TECHNICAL SERVICE BULLETIN

Seat Pan Looseness, Lateral Movement, Or Clunk/Thump Noise On Turns

22-2104

This article supersedes TSB 21-2236 to update the models and year affected.

Figure 2

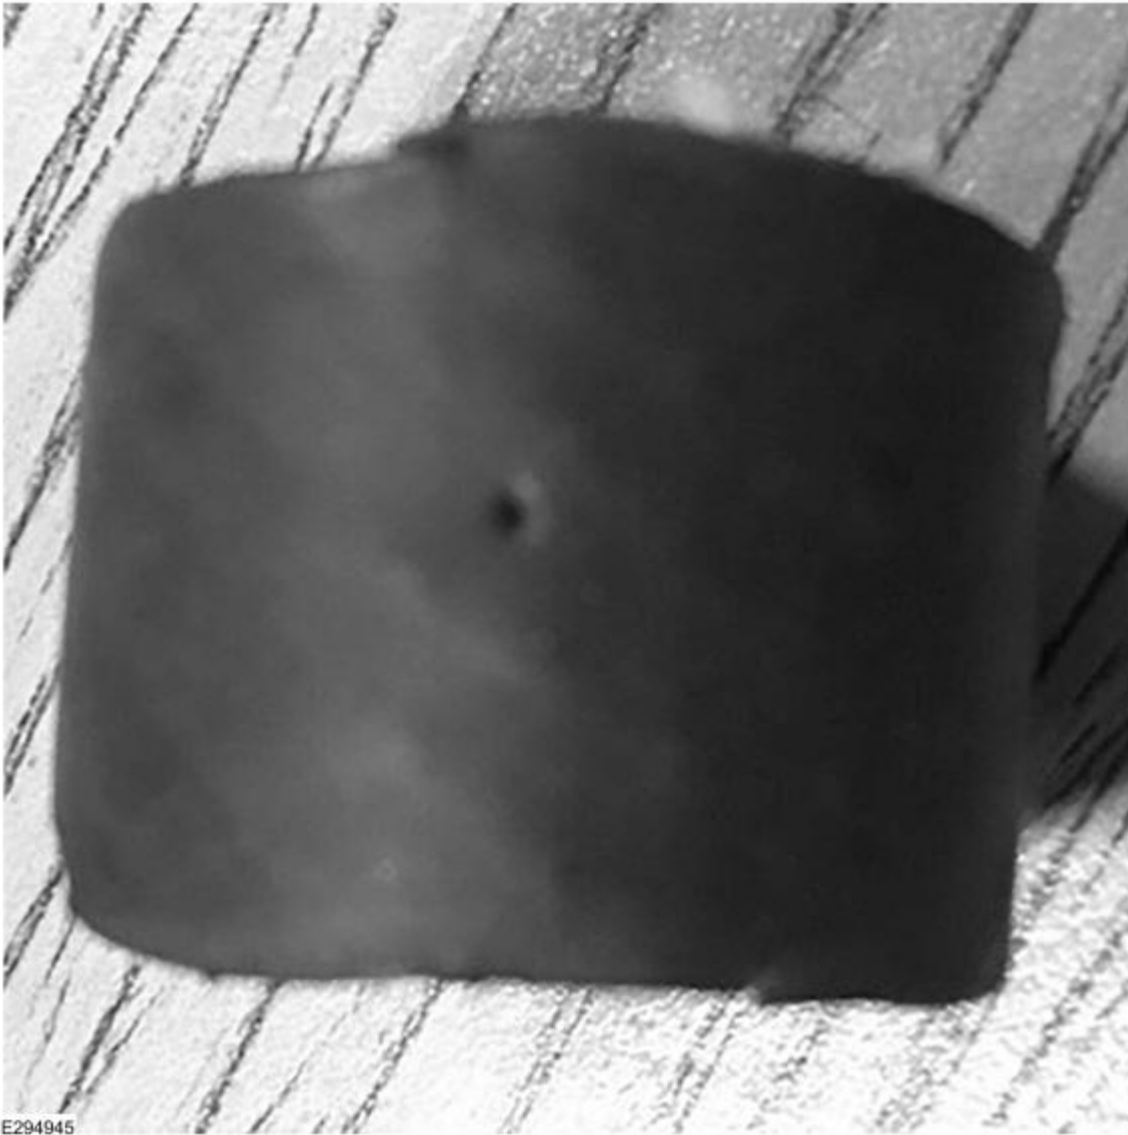
5. Cut a 1 inch (25.4 mm) long section of 3/4 inch (19 mm) diameter heater hose. (Figure 2)

Figure 4

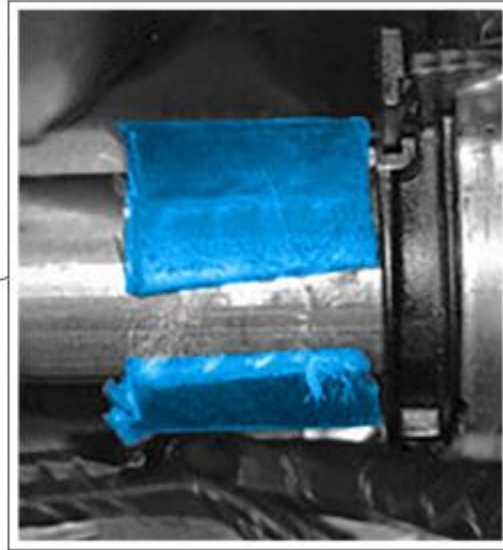
7. Install the heater hose over the front cross tube. (Figure 4)

Figure 5

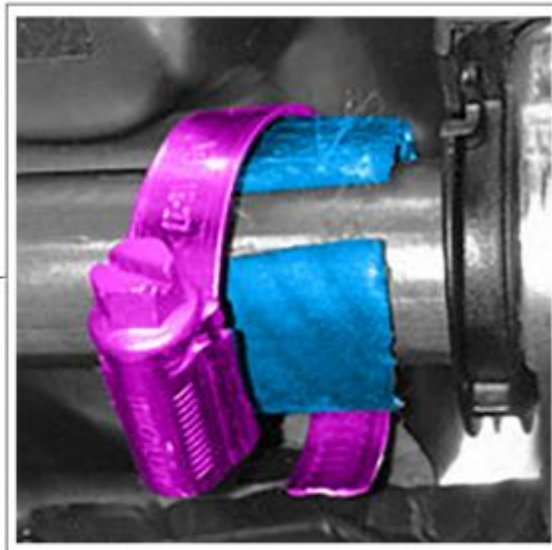
8. Open the hose clamp and slip the hose clamp over the heater hose, securing the heater hose to the front cross tube. (Figure 5)

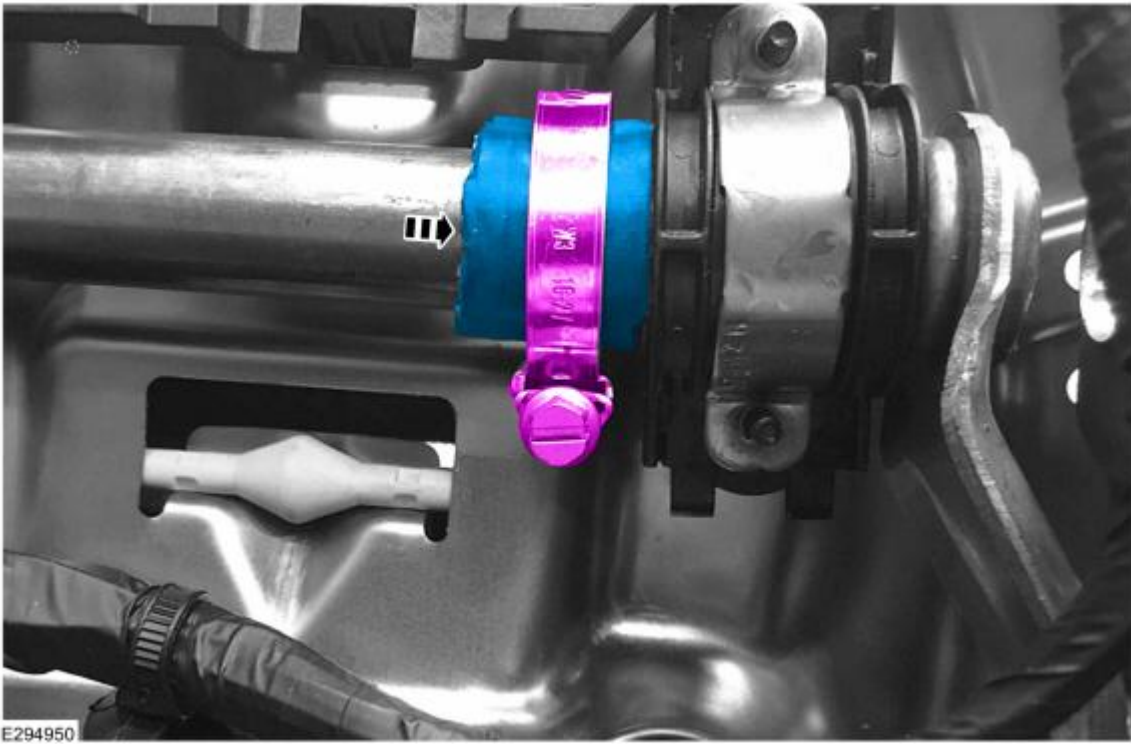
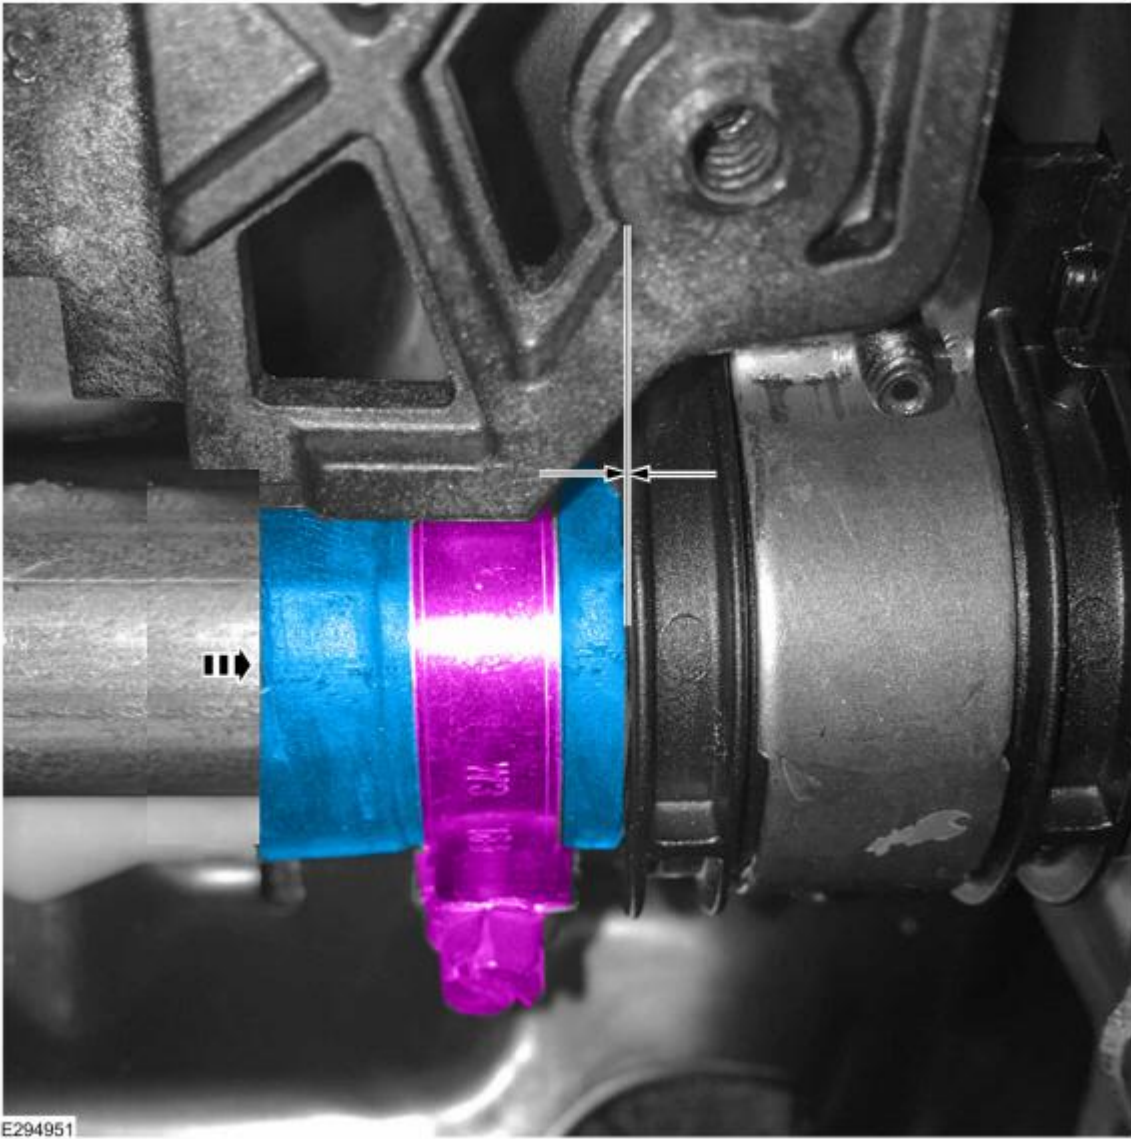
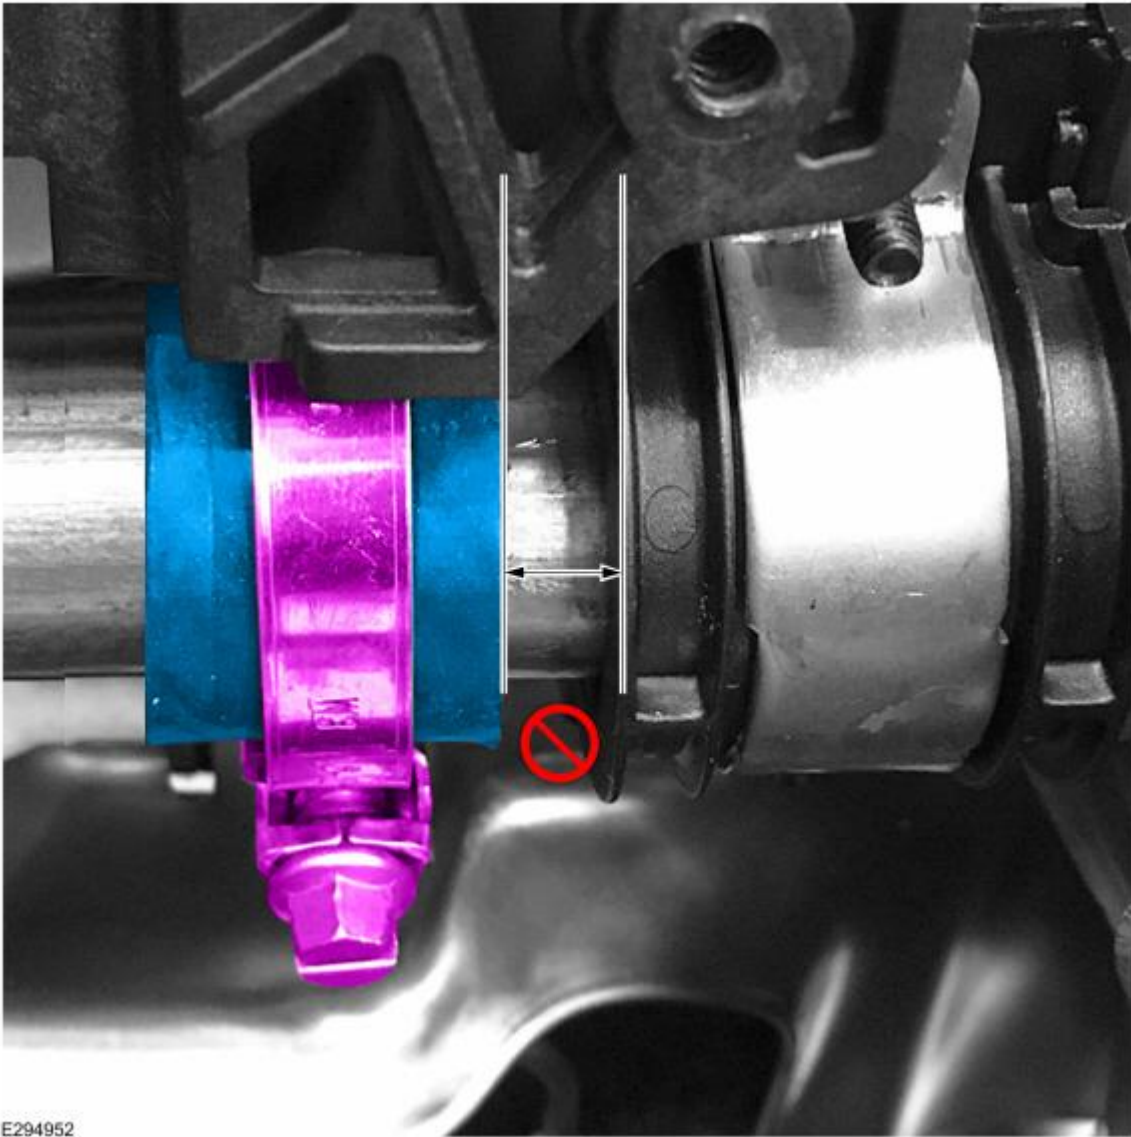
9. Push the heater hose against the handcuff bracket and tighten the hose clamp to 3.7 Nm (33 in-lbs). (Figures 6-9)
Refer to Figures 6-7 for clamp orientation.
